Product Bulletin # **CDS-014** Rev 1

Use of Proper Insert/Stop Plate Kits

Figure 1: Fully Assembled 4-1/2" to 10-3/4" Auto SJ Elevator

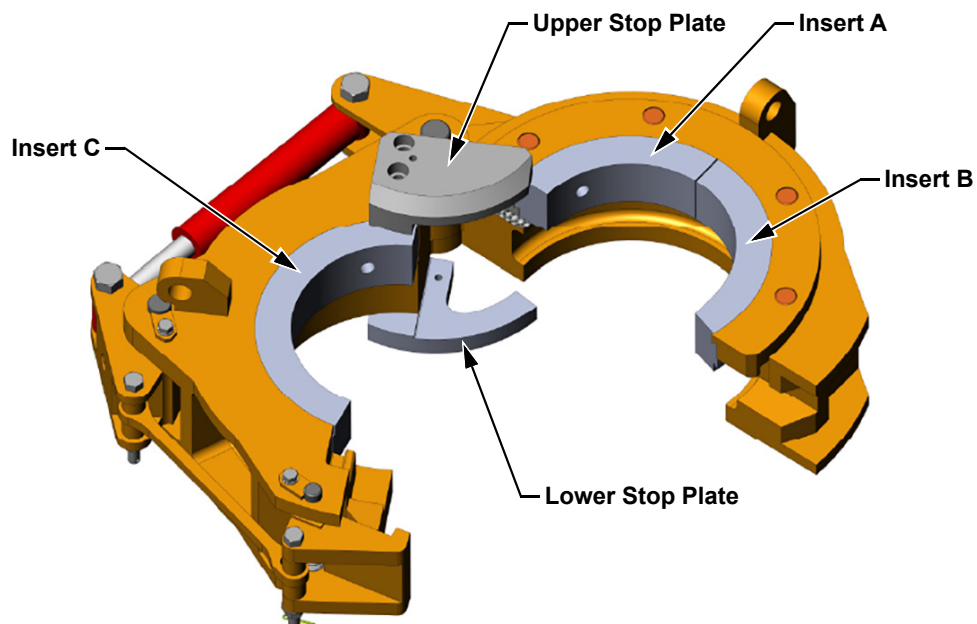
It came to Canrig's attention that premium casing with special coupling OD has been run with existing Insert/Stop Plate Kits, during uncommon set-up and operations conditions. This resulted in one of the two Lower Stop Plate bolts being sheared and a potential dropped object event.

- Use available Insert/Stop Plate Kits for the specified casing size only.
- Always change the inserts together with the Upper and Lower Stop Plates that are included in the same casing size Insert/Stop Plate Kit Bill of Materials (BOM).
- Mixing and matching of various casing size Inserts/Upper Stop Plates/Lower Stop Plates is NOT permitted.
- Contact Canrig for solutions to run Insert/Stop Plate Kits with premium and/or special casing.
